The Gardens At Holcombe Green ZONING PLAN 8-Z

PETITION NO: Z-8

PROPOSED USE: Senior Residential
Community

Z-8 PALLADIAN, INC.

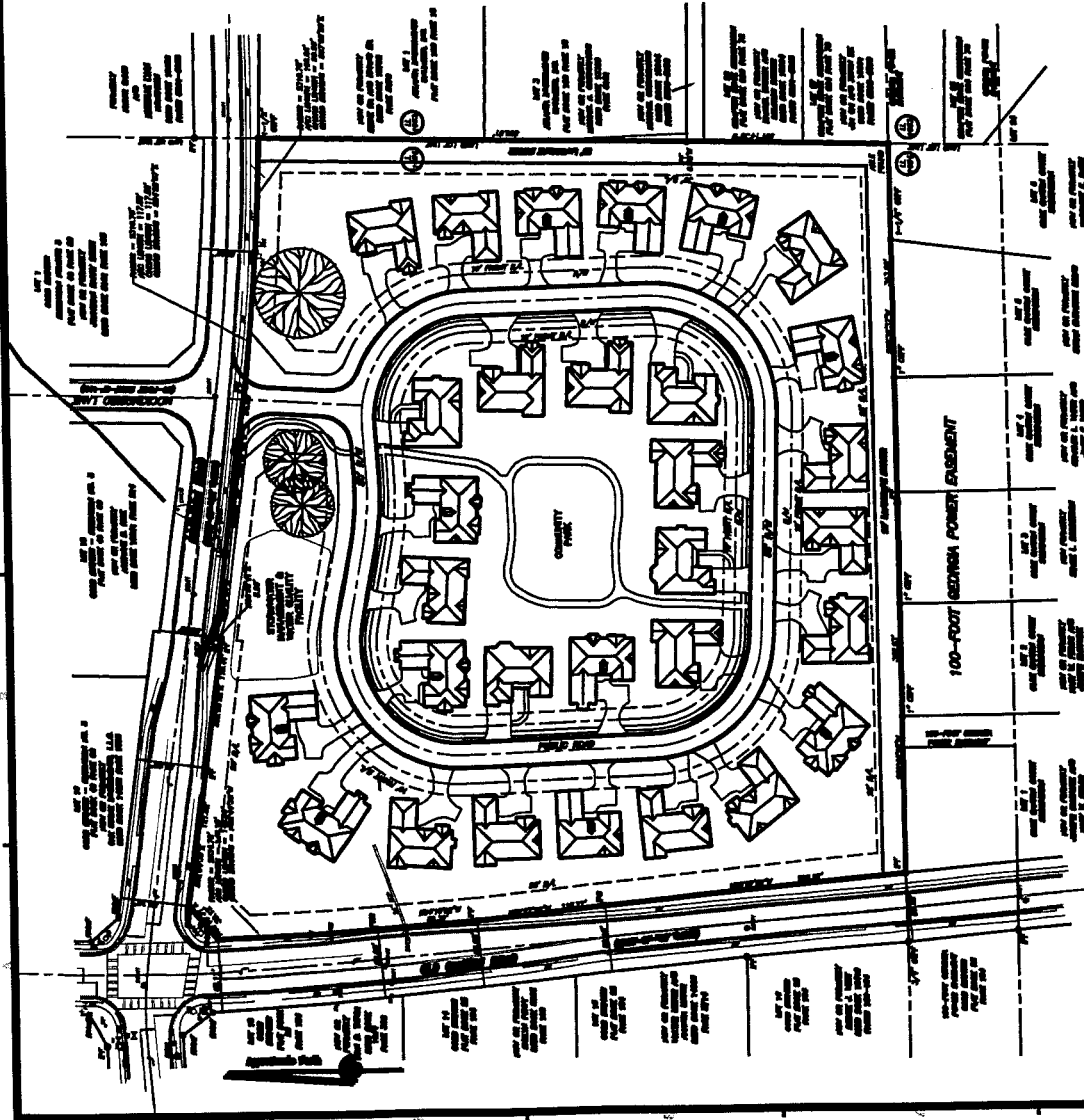
1. Although slopes on the site are moderate, the intensity of the proposed development will require clearing and grading of the majority of the site. However, the proposed impervious area is well below the allowable for RSL developments (55%) and only slightly above the allowable for the current underlying R-20 Zoning Category (35%). No elevated water quality or detention requirements will be imposed, unless there is an issue with limited downstream capacity of the existing stormdrainage system determined during Plan Review.

Align proposed access with Mockingbird Lane.

Recommend aligning the proposed street with Mockingbird Lane.

- Site plan approval be the Board of Commissioners';
- Maximum of 2.5 units per acre (23 detached lots);
- Fire Department comments;
- Water and Sewer comments and recommendations;
- Stormwater Management comments and recommendations;
- DOT comments and recommendations;
- owner/developer to enter into a Development Agreement pursuant to O.C.G.A. §36-71-13 for dedication of system improvements to mitigate traffic concerns.
